**MERIDEN SCHOOL**

**RESPONSE TO  
SUBMISSIONS**

PREPARED FOR MERIDEN SCHOOL

Figure 1 - School Traffic Management Signs and Zones

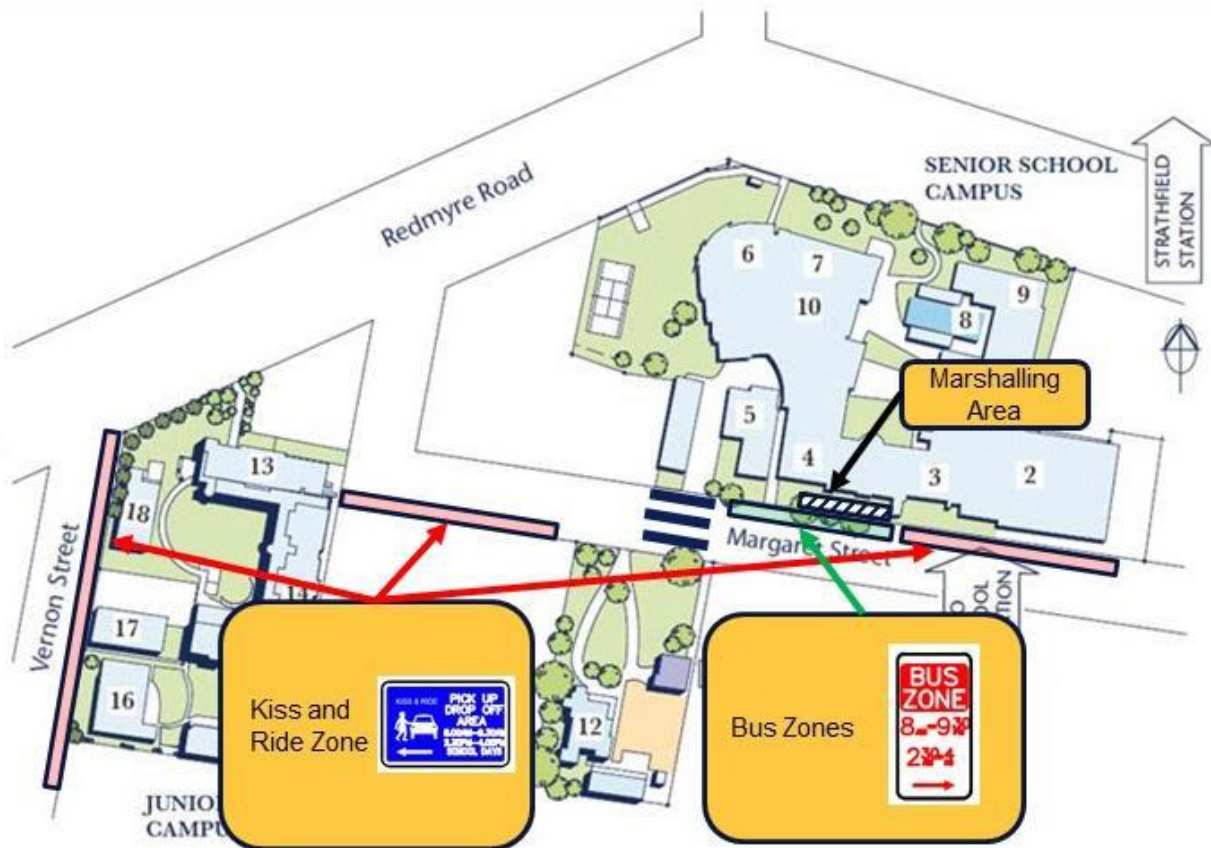
DPIE, RMS and TfNSW requested that a Traffic and Parking Management Plan (TPMP) be provided to support the SSDA which addresses:

School traffic management zone is illustrated below. Figure 1 also demonstrates the pick-up / drop-off zones on Vernon Street and Margaret Street and the bus zone on Margaret Street.

On-street parking spaces are available along Margaret Street, Redmyre Road and Vernon Street. These on-street spaces are time-restricted and are mainly used as designated pick-up/drop-off (PUDO) areas for the school campuses between 8.00am-9.30am and 2.30pm-4.00pm school days.

As detailed in the TPMP, on-street parking rules and restrictions are required to be followed by parents wishing to pick-up / drop-off their children at the school. When "No Parking" and "No Stopping" parking

PUDO spaces are to be utilised efficiently and quickly to minimise queuing times. The TPMP requires that all PUDO drivers are to display their child's names on the dashboard to allow PUDO supervisors to efficiently direct the students to their vehicles.

Figure 2 - Desired Pedestrian Routes between School Campuses

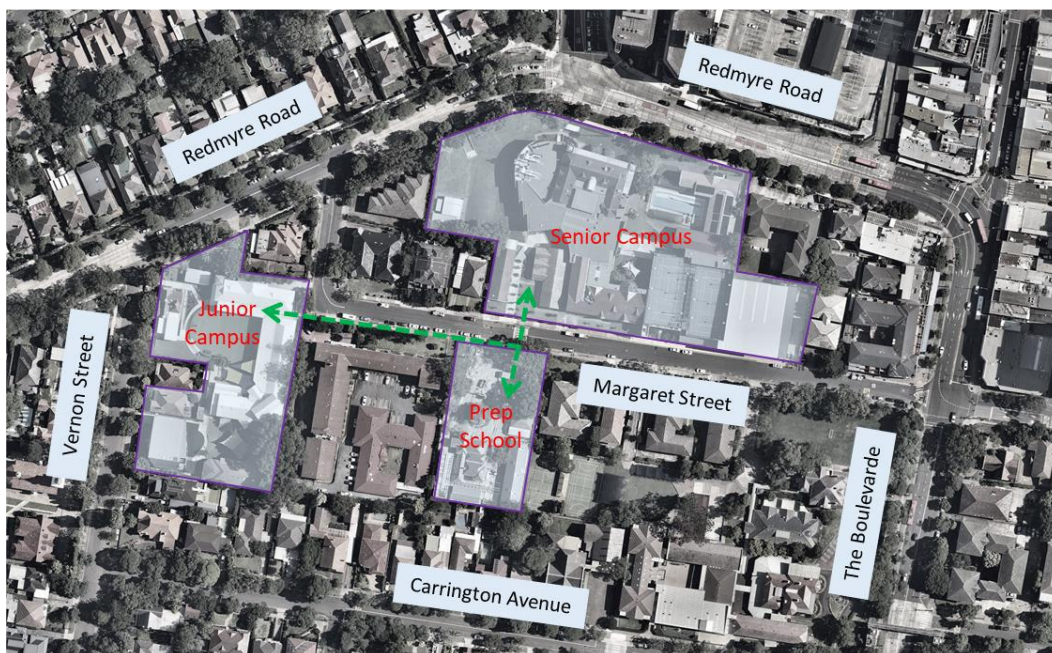
As detailed in the SSDA, the existing pedestrian access points into Meriden School will be retained (refer to Figure 2). There are multiple main pedestrian accesses along Vernon Street for the Junior Campus and along Margaret Street for all three Meriden School campuses.

It is evident from on-site observations that most students, parents and staff walking to and from the school campuses utilise the desired pedestrian routes detailed in Figure 3. It is particularly noteworthy that these routes coincide with the designated pedestrian crossing on Margaret Street.

Pedestrian access is provided by the existing footpaths along Margaret Street, Redmyre Road, The Boulevarde, Raw Square and the majority of roads within the Strathfield Town Centre. These existing footpaths are generous in width, especially at Margaret Street (the desired pedestrian route) with footpath widths of up to 2.5m provided on both sides of the road. Footpaths near the Strathfield Town Centre are wide and well-integrated into the street amenities to handle large pedestrian volumes. Signalised crossings near the vicinity of the school are available at the following key intersections:

As discussed, a key mid-block pedestrian crossing is located at Margaret Street, which links the southern Lingwood Campus and Junior Campus to the northern Senior Campus. A Crossing Supervisor attends this pedestrian crossing during the peak pick-up and set-down school periods.

Figure 4 – noise contours

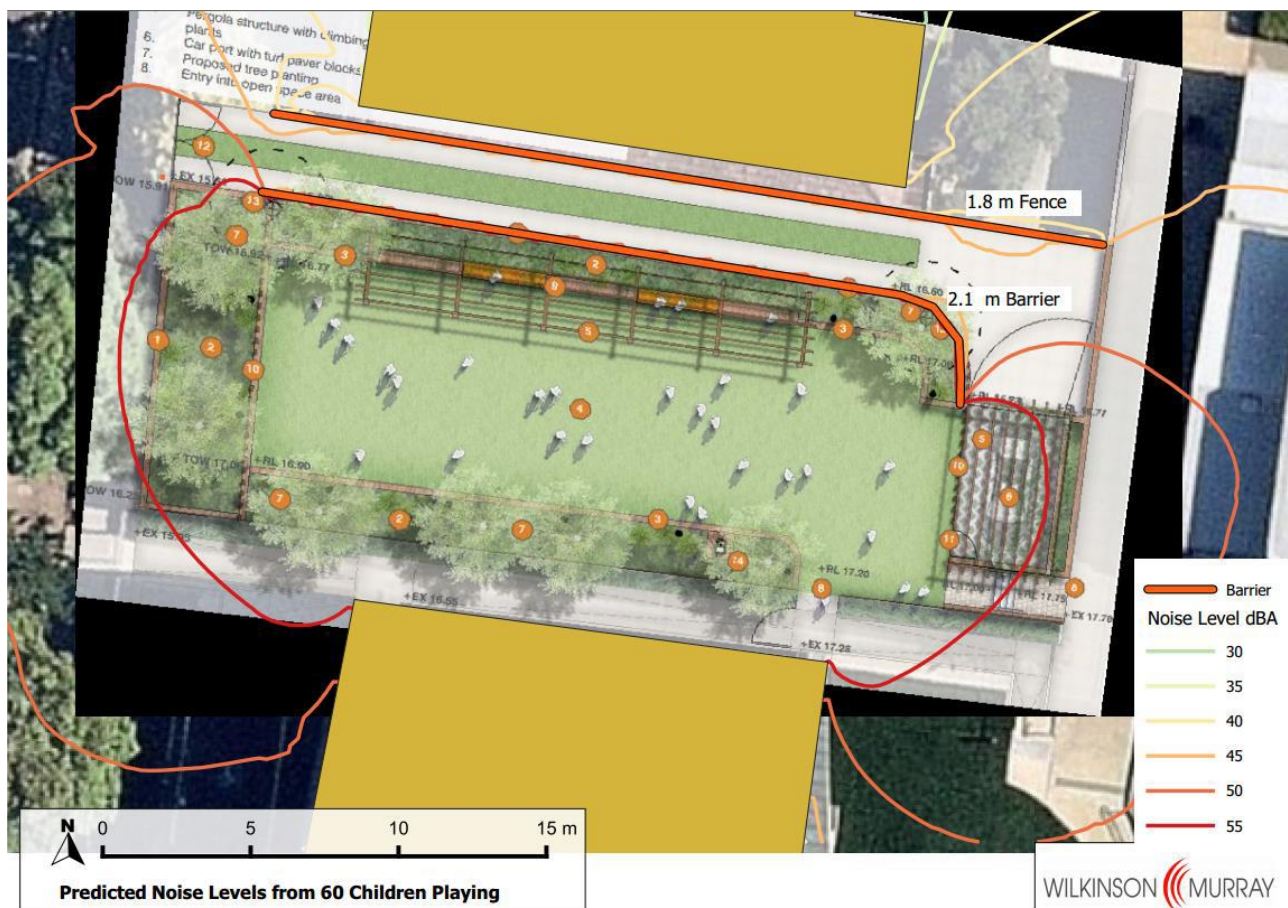
Submissions received by DPIE and surrounding neighbour requested further clarification regarding acoustic measures and the design of the acoustic wall proposed to be installed along the boundary of the proposed playground area within the Junior School Campus.

An updated noise assessment of the proposed playground and its potential acoustic impact on 2 Vernon Street is addressed in detail in the updated Construction and Operational Noise Report prepared by Wilkinson Murray attached at Appendix B. The findings of this updated report are summaries below.

Based on the above scenarios, the following LAeq (15 minute) noise levels at 2 Vernon Street are predicted indicating compliance with the following established noise criteria:

- 36 Children in PE class 23 dBA.
- 60 Children at Play 42 dBA.

The noise contours shown in Figure 4 is based on the 60 Children playing scenario, which is the maximum number of children occupying the space within a given time.
